DELEGATED APPLICATION REPORT

App Ref: PL/26/0169 Non-Material Amendment

Address: 50 CARDIFF ROAD, READING, RG1 8EP

Proposal: Non-Material Amendment following a grant of Planning Permission PL/24/0581 to raise the rear parapet wall as built.

Previously approved plans under permission PL/24/0581: Drawing No. 1150/05 A, received 21/06/24

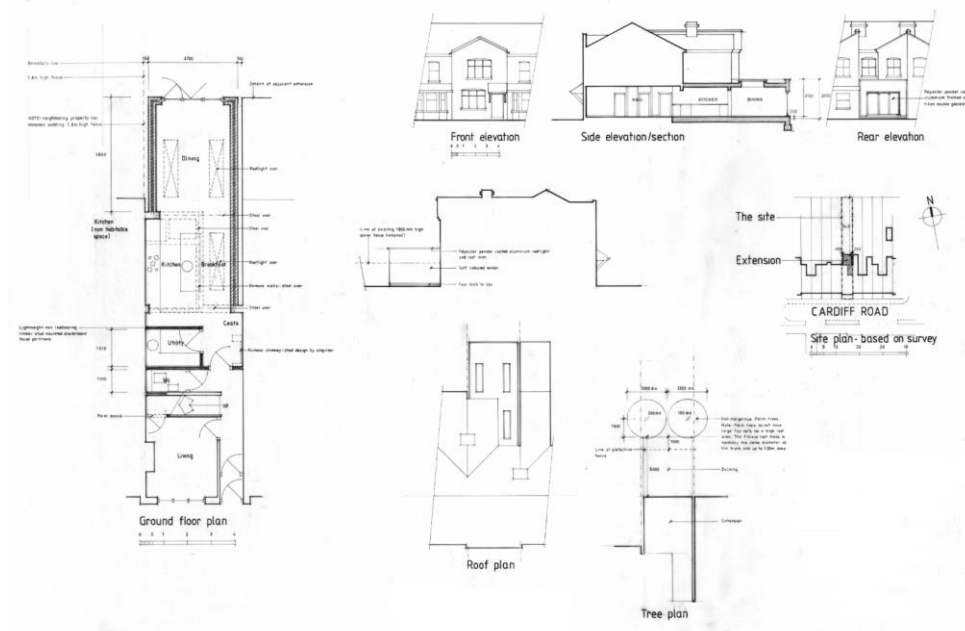
The main differences between the construction as built under this application and the approved plans under PL/24/0581 are as follows:

- Overall height: The construction as built under this application has an overall height of approximately 3.3 m, including the height of the unapproved parapet, whereas the approved overall height was approximately 3.2 m, including the rooflight but with no parapet.
- Rear-facing door: The rear-facing door, as installed, is lower in height than the approved door.

The proposed non-material amendment to application PL/24/0581 seeks to add a parapet wall above the roof level as built. Other elements, except for the smaller rear-facing door, remain largely unchanged from those approved under planning permission PL/24/0581.

This application relates specifically to the construction of the parapet wall. It is noted that the overall height as built slightly exceeds the approved height by approximately 7–10 cm. While the difference is minor in numerical terms, the resulting height forms part of a parapet whose design is visually dominant and overbearing to neighbouring properties, particularly given that the site is a mid-terrace dwelling with a narrowed rear garden.

Therefore, the proposal is not considered a non-material amendment, as the overall height exceeds the approved height and the parapet design is judged to have a detrimental impact on neighbouring properties due to its visually dominant and overbearing appearance.
